AGENDA

Historic District Commission Meeting

7:00 PM - Tuesday, April 26, 2022

Photo by R.A. Schweitzer, 1981. Property file.

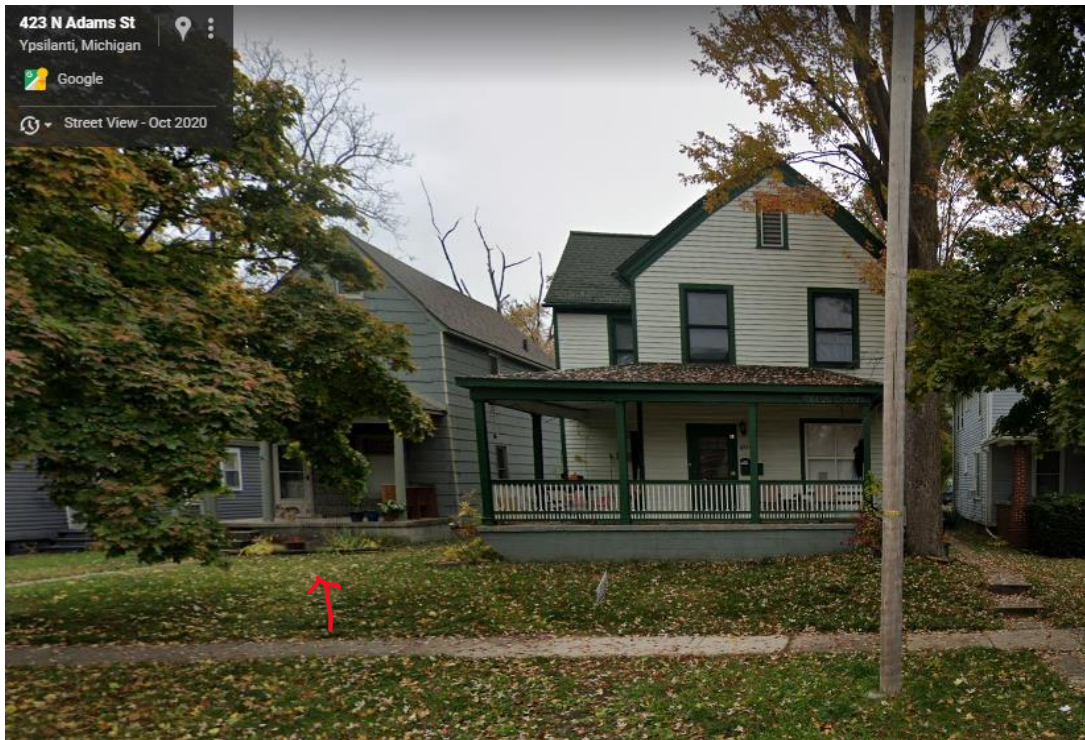
The red arrow marks 421 N Adams and this photo shows the side of the roof where the skylight would be installed, toward the rear.

Move to approve the application received April 13, 2022 and issue a certificate of appropriateness for the proposed work at 421 N Adams for the installation of a Velux skylight on the house's north side toward the rear. The proposed work meets the Secretary of the Interior's Standards, specifically Standards 2 and 9, because it will not remove or destroy original features or character and it is compatible.

WEST ELEVATION
3/16" = 1' - 0"
- 18 NORTH WASHINGTON -

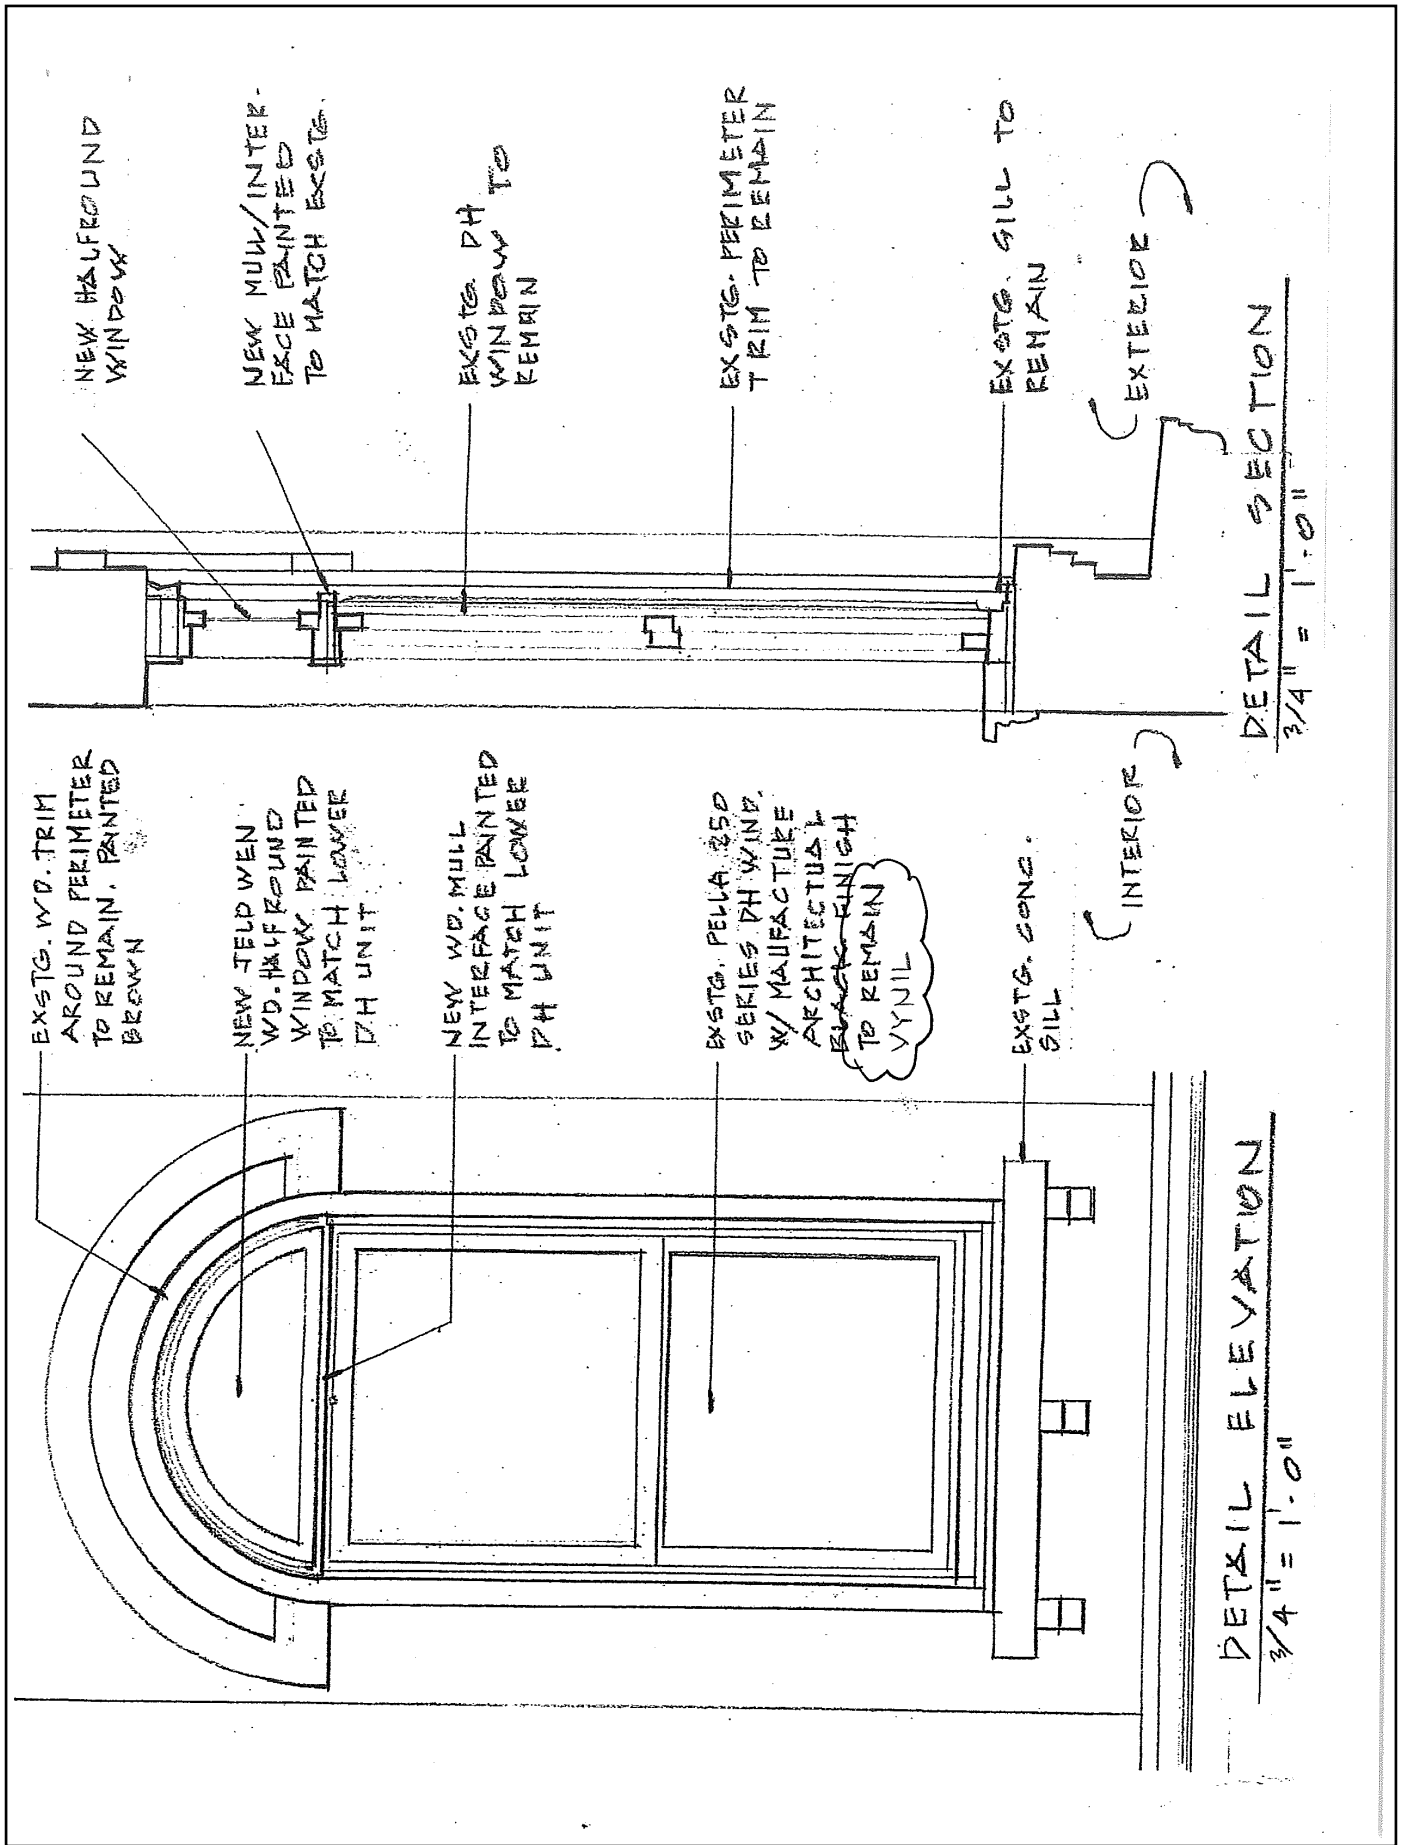
1. The windows that were in place in 2019 had tall, thin proportions and were arched to fit the window openings. (See the detail below on page 4.)
2. The sashes that have been installed without a permit have thicker, squarer proportions than the windows that had been there. Currently, boards cover where the rounded upper sash was.

- b. The old windows had a different design than the current windows—the old windows had a thin, central muntin that emphasized the vertical. The current windows lack that muntin detail altogether, so their sense of proportion is different—they are much squarer instead of tall and arching.
